Staff Summary Report

Development Review Commission Date: 05/22/07

SUBJECT: Hold a public meeting for a Development Plan Review for MICRO-TRONICS LOT 55 located at 2922 South 52nd Street.

COMMENTS: Request for **MICRO-TRONICS LOT 55 (PL070081)** consists of a 17,300 s.f. manufacturing and office building with two levels of office and a single level machining area, on 1.08 net acres, in the General Industrial Zoning District. The request includes the following:

SITE PLAN
 PROJECT NUMBER: 07011
A1.0

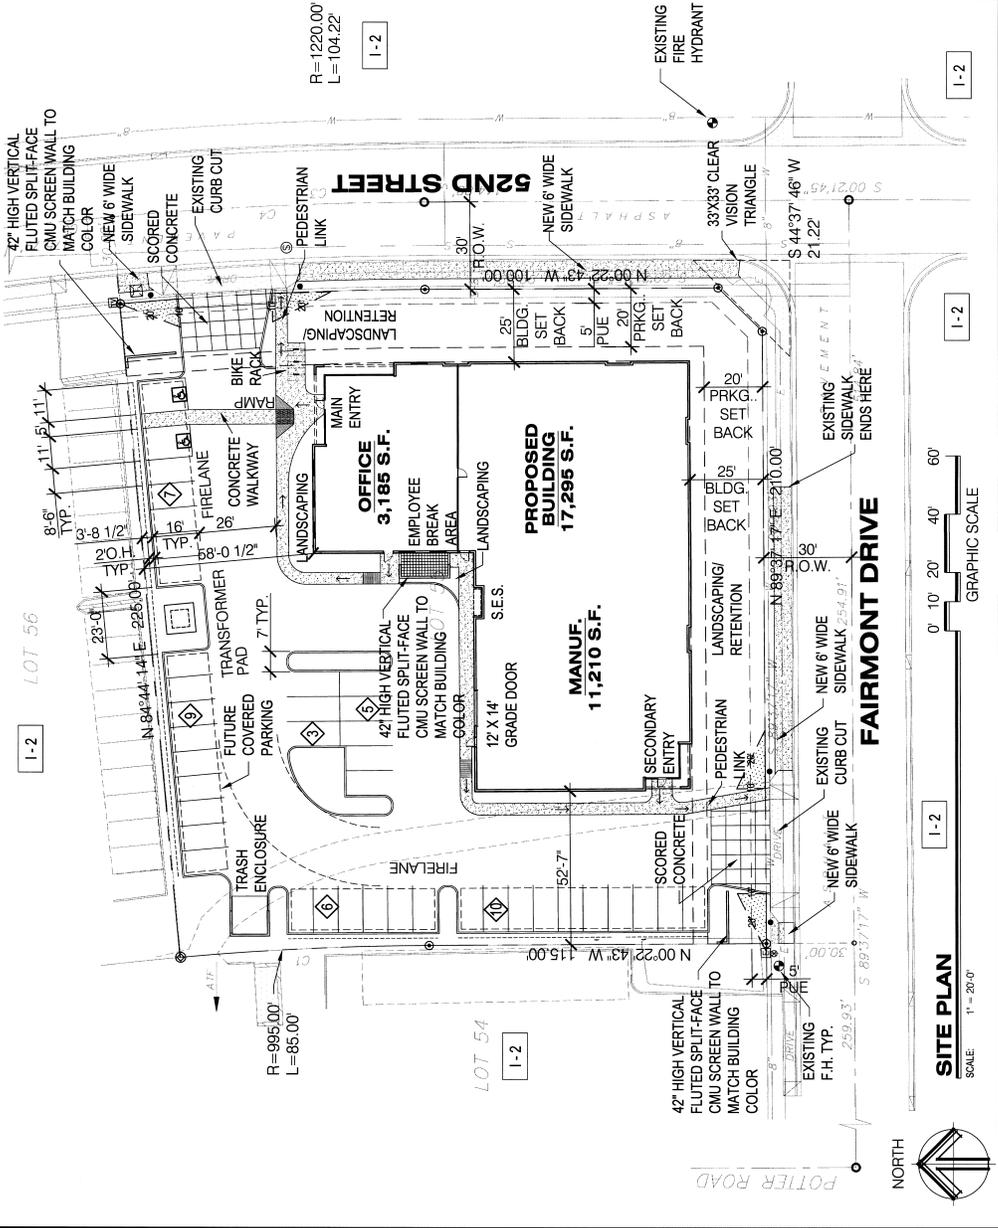
2. Remove one parking space and expand adjacent landscape island near northwest building corner to keep required tree canopies out of way of fire lane. Refer to illustration on the Site Plan Review dated 5/9/07.

3. Near the northeast building corner, shift bike parking west out of the 20'-0" wide parking setback.
 4. Maximize surface retention system prior to utilizing sub-surface retention structures. Consider use of surface retention on paving as an alternative to the retention concept indicated. Contact Engineering ([steve horstman@tempe.gov](mailto:steve_horstman@tempe.gov)) to discuss retention concept.

5. Provide screen walls of fluted CMU facing street with 4" nominal solid caps.
 6. Correctly indicate T-320 driveways with level disabled pedestrian sidewalk bypass on the site plan. Provide upgraded paving at each driveway apron consisting of unit paving. Extend unit paving in the driveway from the back of the level accessible public sidewalk bypass to minimum 20'-0" on site and from curb to curb at the drive edges. If the back of the accessible sidewalk bypass is on the property, upgraded paving consisting of scored concrete as indicated is acceptable.

9. Shade canopies for parking areas:
 - a. Pull canopy one space away from adjacent landscape island where island is the minimum width, so the tree canopy has room to expand. Refer to illustration on the Site Plan Review mark-up dated 5/9/07.

- Clearly indicate property lines and the dimensional relation of the building to the property lines.
 - Reconcile north building setback dimension on site plan with setbacks listed.

PRELIMINARY GRADING AND DRAINAGE for MICRO-TRONICS LOT 55 TEMPE, ARIZONA

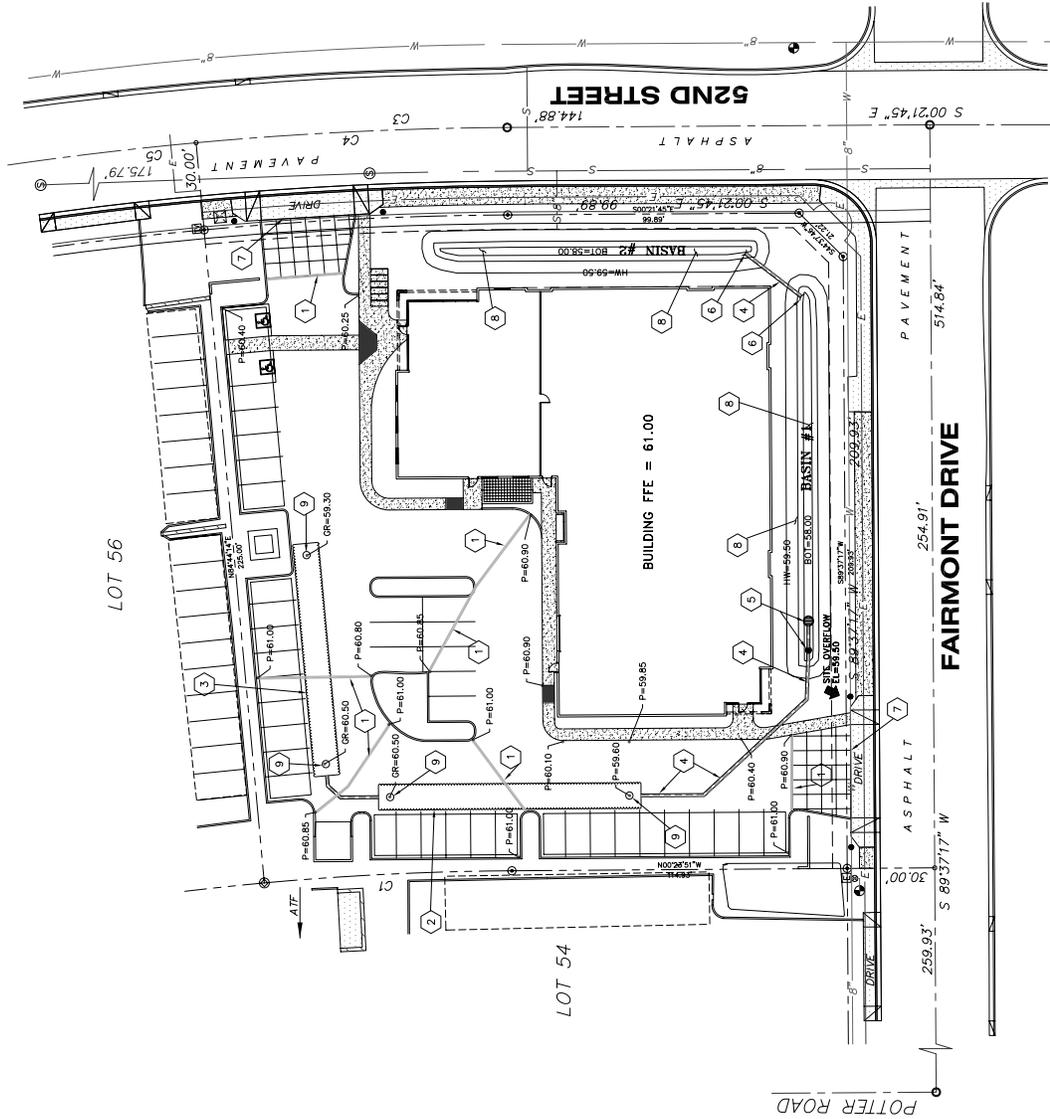
- Reconcile gross site area between the architectural site and grading and drainage plans.
- Verify location of any easements, or property restrictions, to ensure no conflict exists with the site layout or foundation design.

MICRO-TRONICS LOT 55
CONCEPTUAL LANDSCAPE PLAN

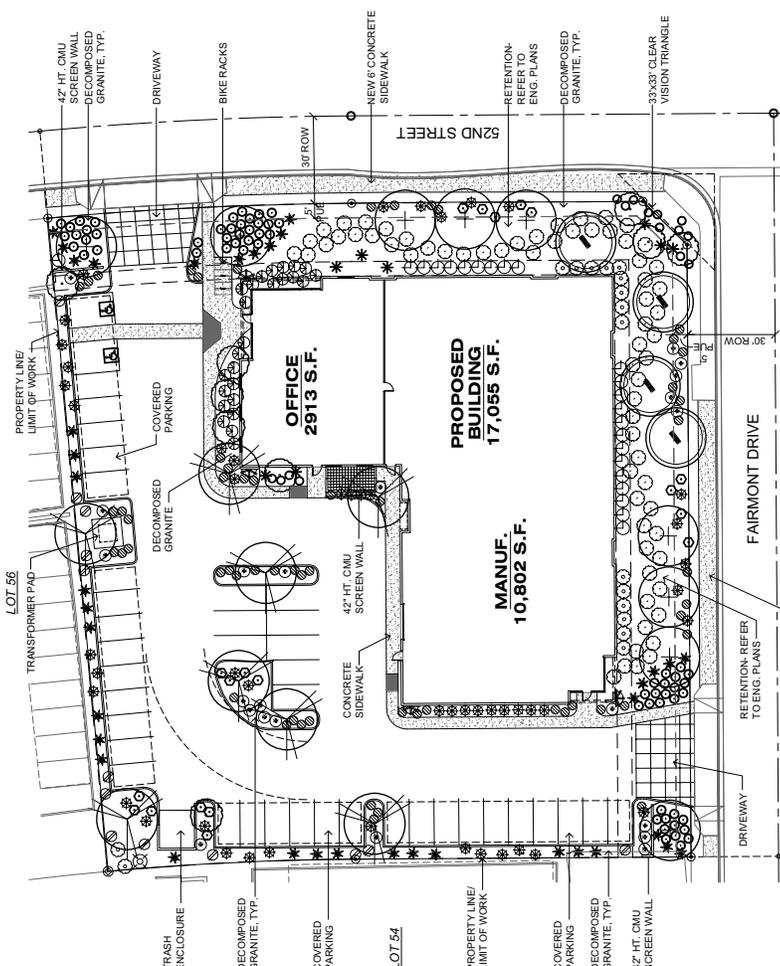
23. Remove project data other than landscape areas from landscape plan.
24. Irrigation notes:
 - a. A separate dedicated landscape water meter is recommended (not required) to separately measure landscape water and avoid a sewer charge on water used for landscape.

- f. Repair existing irrigation systems on properties to north and west of this site where these systems are disturbed by this construction.
25. Protect and do not disturb existing plant material, particularly trees, which are adjacent to this site. Locate existing trees which are adjacent to the west and north edges of the site, indicate the extent of their canopy and identify by species on the landscape plan. Replace damaged plant material with agreement of adjacent property owner as part of this work.

26. Provide a tree at the required landscape island in the northeast site corner.
27. Provide at least one tree in the wide landscape island that contains the transformer where the tree is in line with the parking row, not behind the island as indicated. Adjust the location of the transformer in the island accordingly. Coordinate tree placement with transformer location adjustment so the transformer is uniformly indicated on the landscape, irrigation, architectural, utility and electrical site plans.

28. At the east double length landscape island near the roll-up door, provide two trees rather than one.
29. At the west double length landscape island near the roll-up door, position the trees so the canopies, as they mature, do not intrude into the 20' wide, 14' high fire lane.

ELEVATIONS
 SCALE: 3/32" = 1'-0"

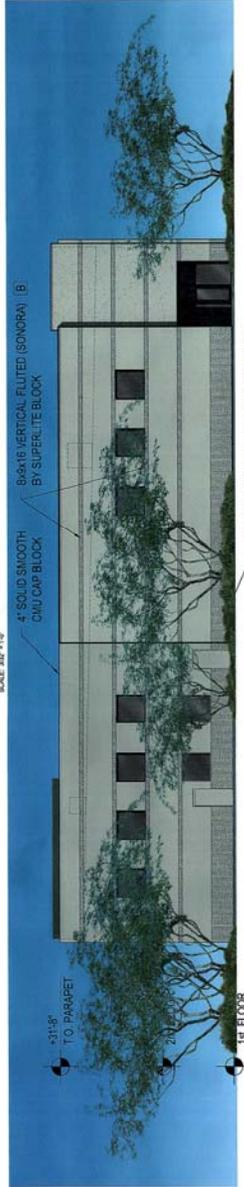
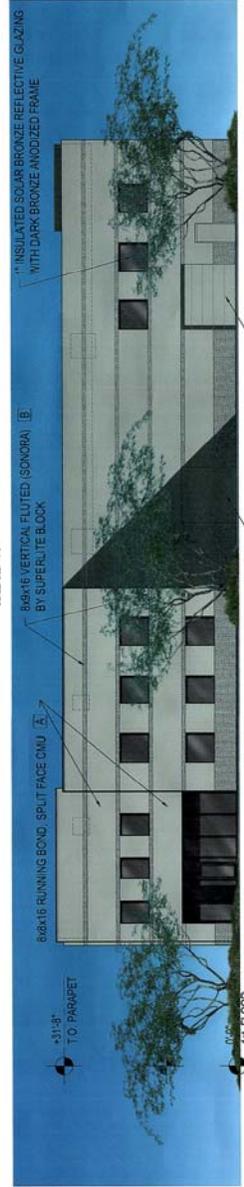
11. Exit Security: at each hollow metal exit door on the north and west elevations, facing the parking area, provide a six inch square vision panel. Provide panel of laminated glass or high strength plastic. Center panel in door at 63" above finish floor.

12. Recessed S.E.S. in north elevation is acceptable. Design S.E.S. cabinet and opening so there is no space above or to the sides of the cabinet at the head or jambs of the opening.

13. Provide minimum 8" square portals at each leg of the two "L" shape columns. Stack the portals three high in each column leg (six per column) to inhibit use of columns as hiding places adjacent to the building entrances. Refer to mark-up in the 5/9/07 Site Plan Review for an illustration of the portals.
